RE: **Lot 19, Block 6, Unit 22 S.A.D. 227**
8000 Camino Alto Ct. NW
Grading and Drainage Plan
Engineers Stamp Date 6/13/19 (D10D003B19)

Based upon the information provided in your submittal received 6/14/19, this plan is approved for Grading Permit.

GRADING AND DRAINAGE PLAN
8000 CAMINO ALTO NW
LOT #19, BLOCK #6, VOLCANO CLIFFS UNIT #22

GRADING AND DRAINAGE PLAN

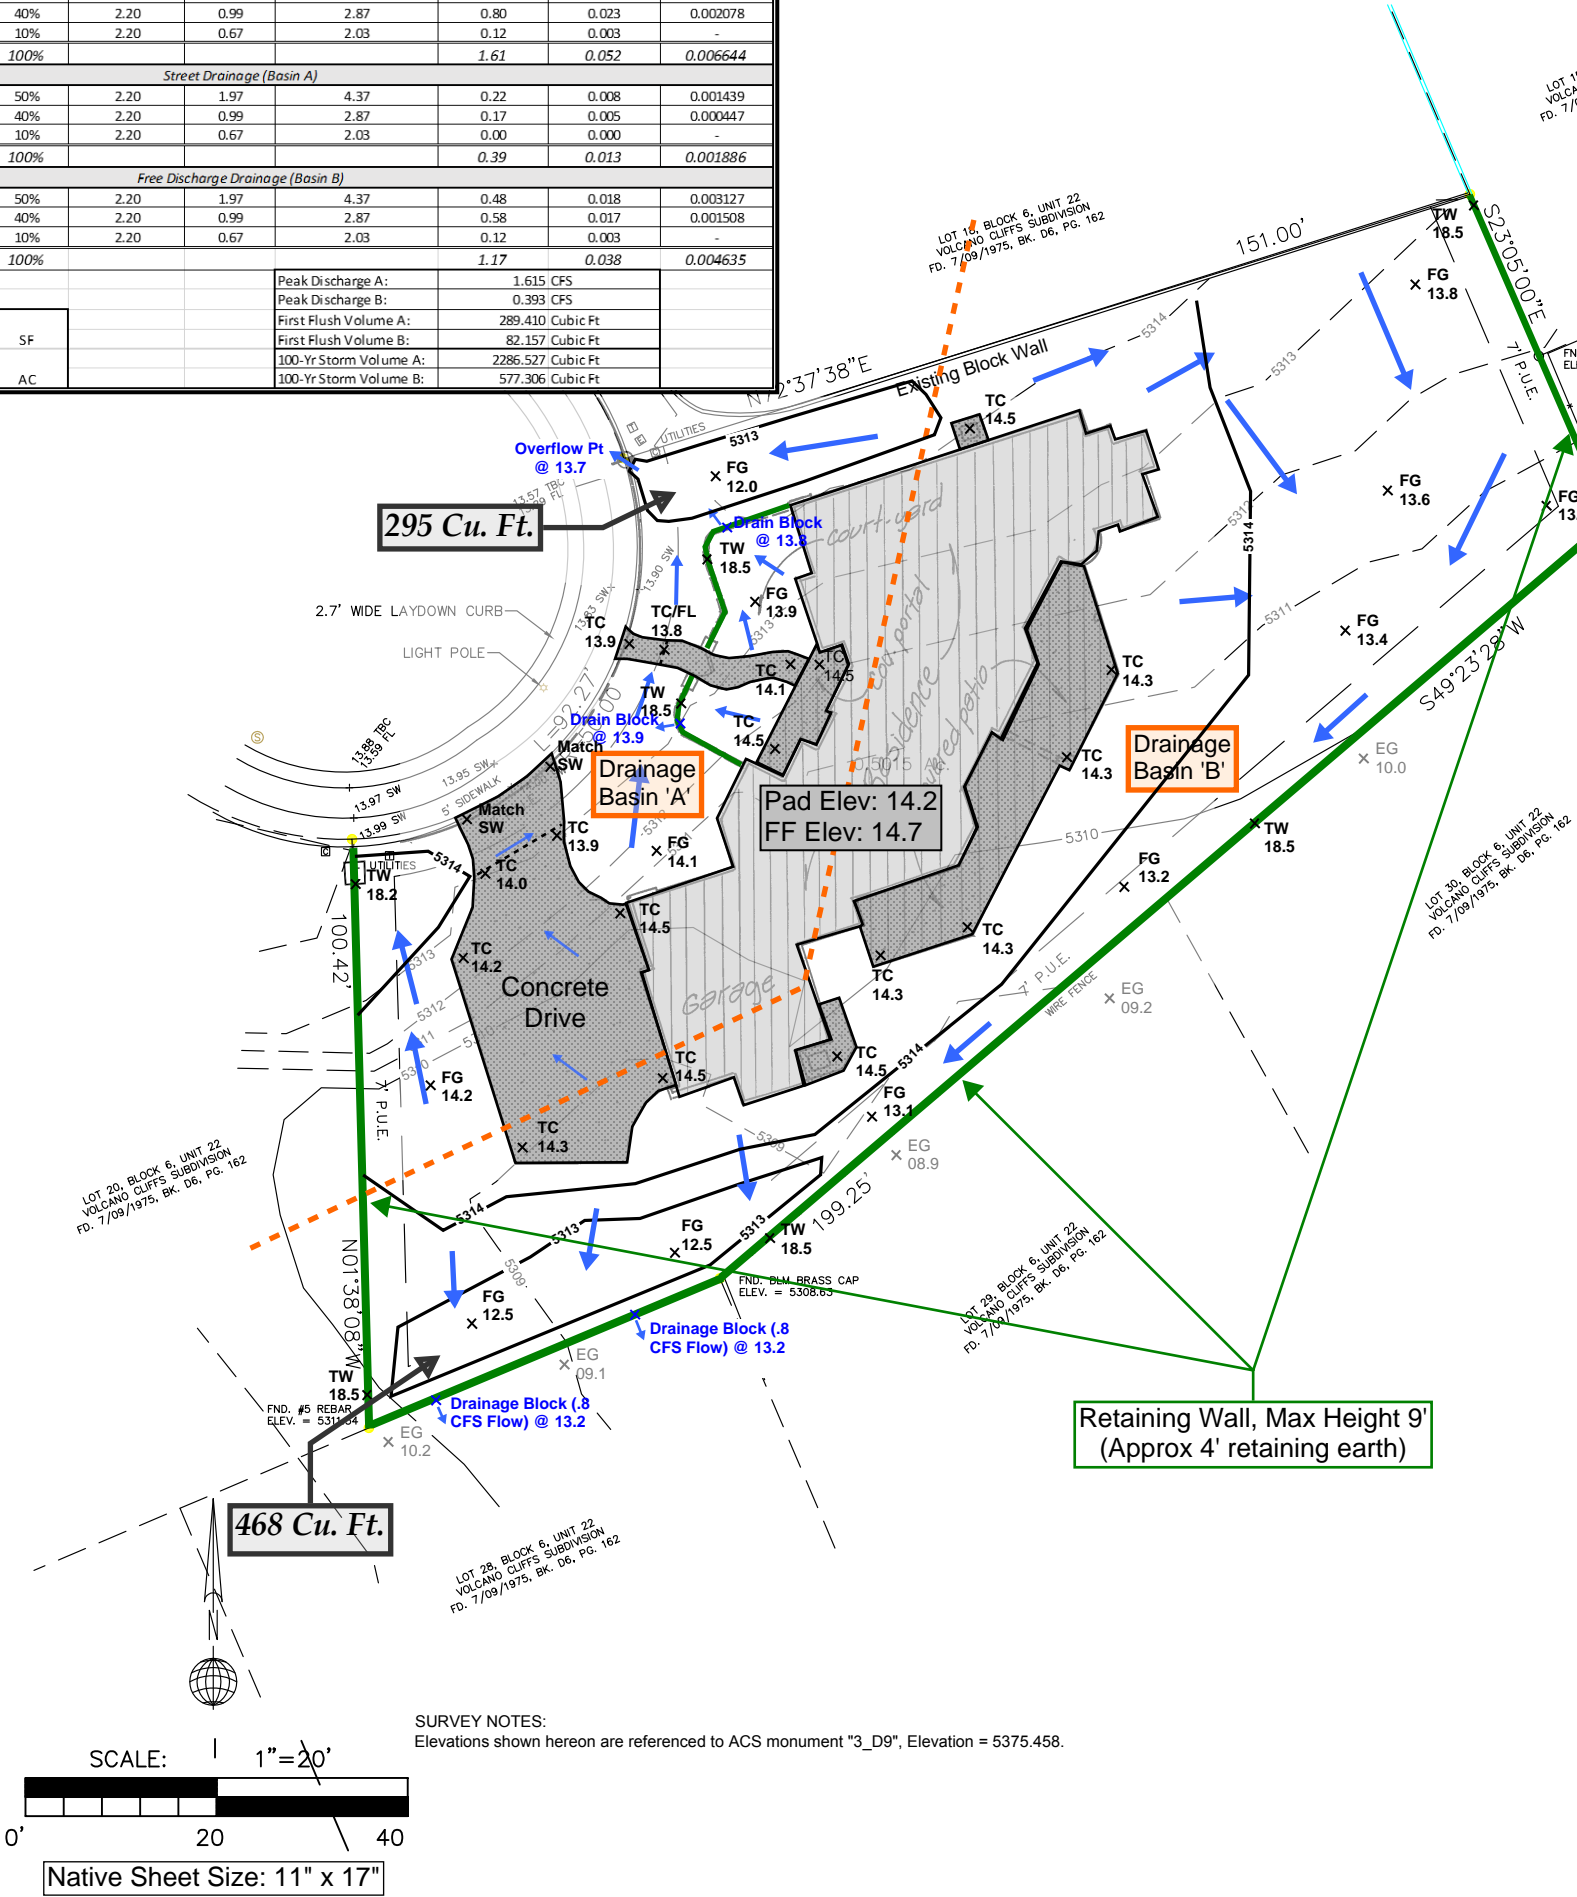
A pad certification is required before concrete is poured, either by a letter from you stating that the pad is built according to the plan submitted or by an as-built with elevations plotted.

Also, please advise the owner/contractor that a separate wall permit must be obtained and this approved grading plan dated 6/13/19 must be provided with the wall permit application.
